COUNTY OF LOS ANGELES
DEPARTMENT OF PARKS AND RECREATION

**VESTING TENTATIVE TRACT MAP 073336 (NORTHLAKE)
PARK CONDITIONS OF MAP APPROVAL AND TRAIL COMMENTS
REGIONAL PLANNING MAP DATED JUNE 7, 2015
SUBDIVISION COMMITTEE MEETING ON JULY 16, 2015**

TRAIL REVIEW: TR073336
 County of Los Angeles | Department of Parks & Recreation

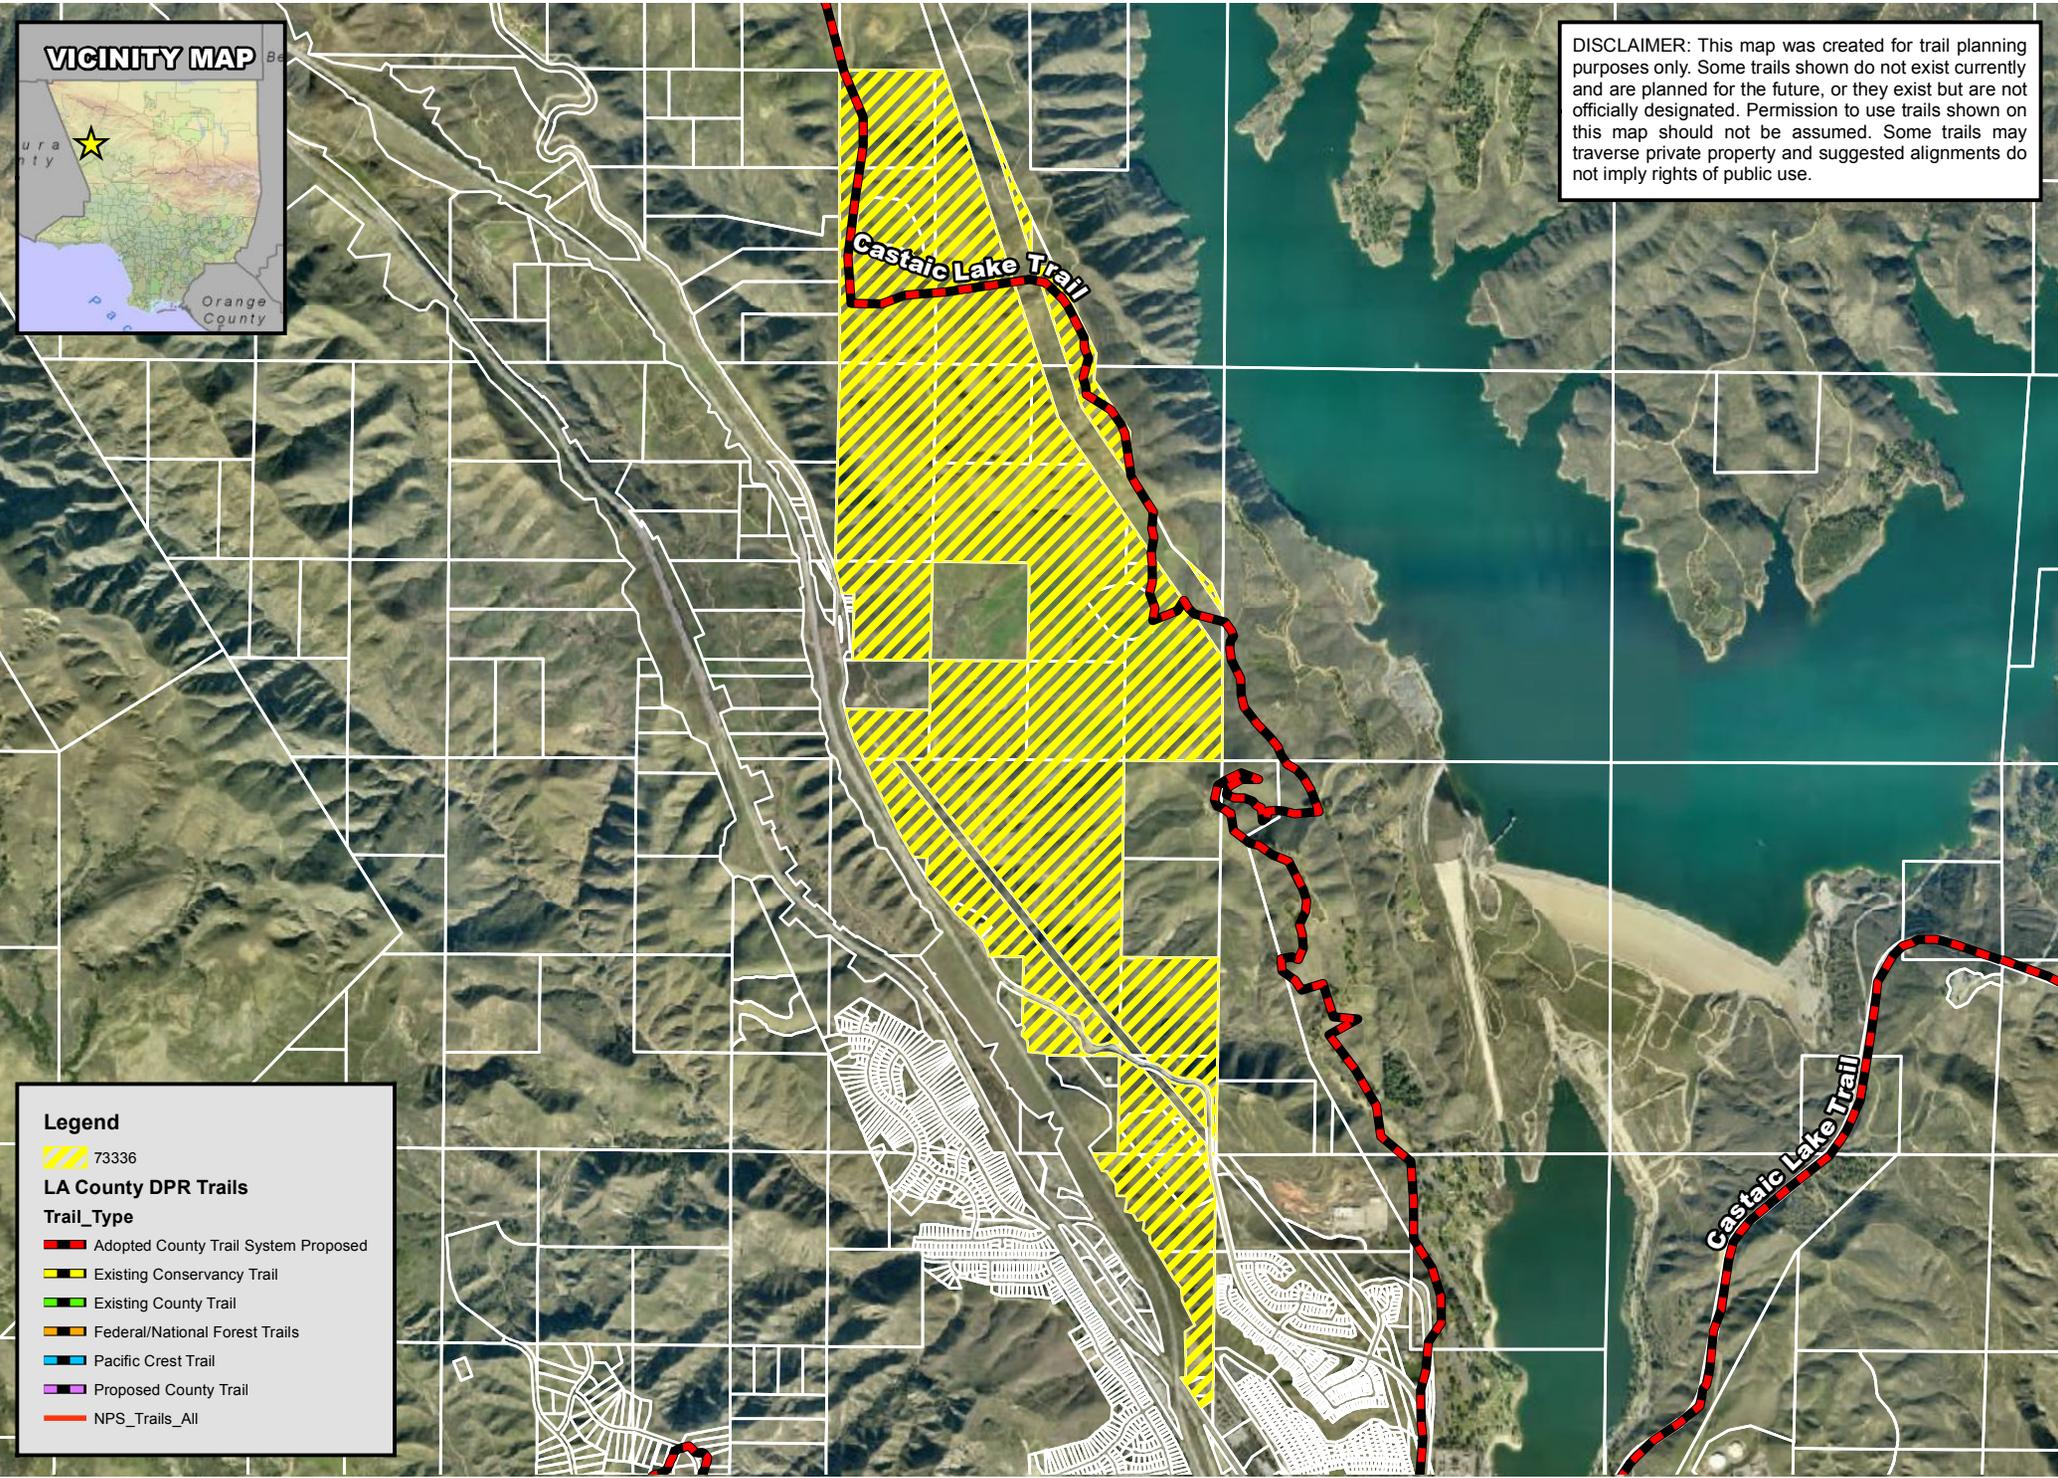
The Department is requiring the Subdivider to dedicate a twenty-foot (20') wide easement to the County for Multi-Use (hiking, mountain biking, and equestrian) trail purposes and construct a variable seven to ten-foot (7 to 10') wide natural trail #1 within the dedicated trail easement to be designated as the Castaic Lake Trail and install appropriate trail infrastructure (see attached trail map).

Map is on HOLD until details of required trail alignment, trail exhibit map, road crossings and pertinent trail section views, as specified below, are defined to the satisfaction of the Department.
